BEFORE THE PUBLIC SERVICE COMMISSION
OF THE STATE OF MISSOURI

| KCP&L Greater Missouri Operations |) | File No. EO-2013-0538 |

COMMENTS OF SIERRA CLUB

Figure 5: Annual DSM energy for RAP and MEEIA-RAP alternatives

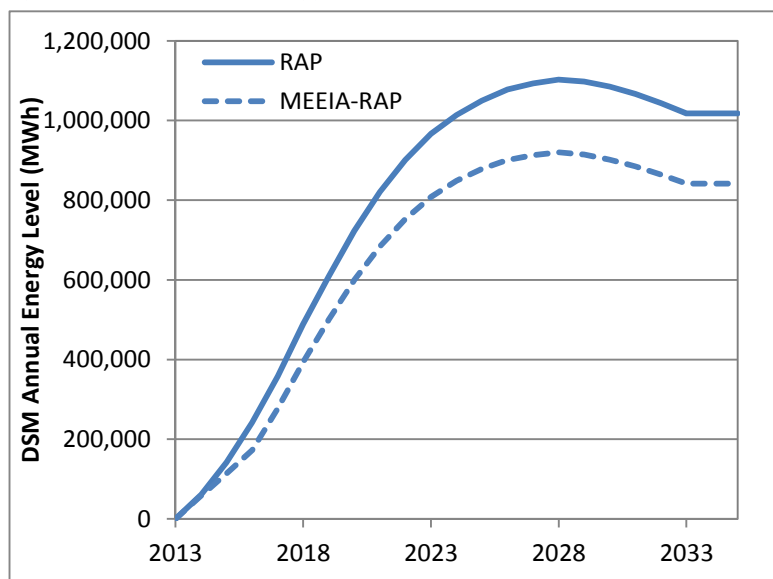
KCP&L’s adjusted MEEIA-RAP forecast is compared to RAP in Figure 5. The reduced spending over a few early years cascades forward, resulting in substantially less cumulative DSM energy savings over the study period. This difference results in the substantial difference in costs and rates of the two plans discussed above.

KCP&L also adjusted the Navigant study downward based on the assumption that 15 percent of C&I customers will opt out of lower-cost DSM, as this is the percentage of GMO customers that have historically requested to opt out. This assumption is not adequately justified. Is the 15 percent opt-out for GMO based on a single year, or several? Perhaps the GMO DSM deployment did not include programs that were appealing to C&I customers, causing them to opt out, which the KCP&L program could improve on. In fact, data from EIA Form 861 indicates individual KCP&L industrial customers use substantially less energy than GMO customers—1,450 MWh per customer per year at KCP&L compared to 5,416 MWh per customer per year at GMO. This large difference in the average energy intensity of respective commercial and industrial customers suggests that using the same opt-out rate for both companies may not be a reasonable assumption.

Figure 6: DSM capacity from Navigant Report and KCP&L's plans

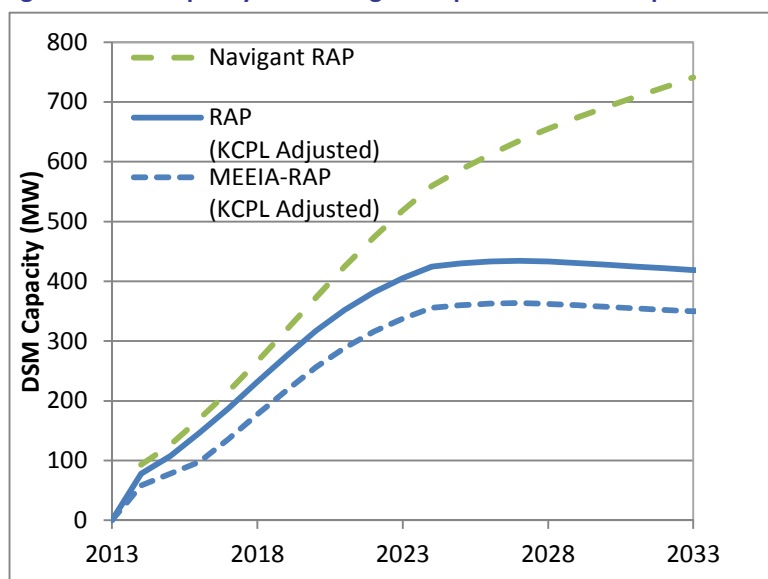
In addition to being an essential low-cost energy resource, DSM also provides demand savings in the form of peak reductions. The cumulative demand savings potential from the Navigant study (Appendix L) grows every year, as shown in Figure 6, eventually rising to a total of 741 MW for KCP&L in the RAP scenario, including energy efficiency (EE), demand response (DR), and combined heat and power (CHP). KCP&L's Stakeholder Report (Appendix B) shows a peak DSM capacity of only 432 MW for the RAP scenario, and 363 MW for the MEEIA-RAP scenario. After the peak year in 2026, the capacity savings associated with DSM flattens and subsequently declines. It is unclear why this decline exists, given the Navigant study's finding of a steadily increasing potential out to 2033. While Navigant shows annual savings may decline as the market becomes more saturated (as indicated for energy in Figure 5), cumulative capacity should continue to increase.
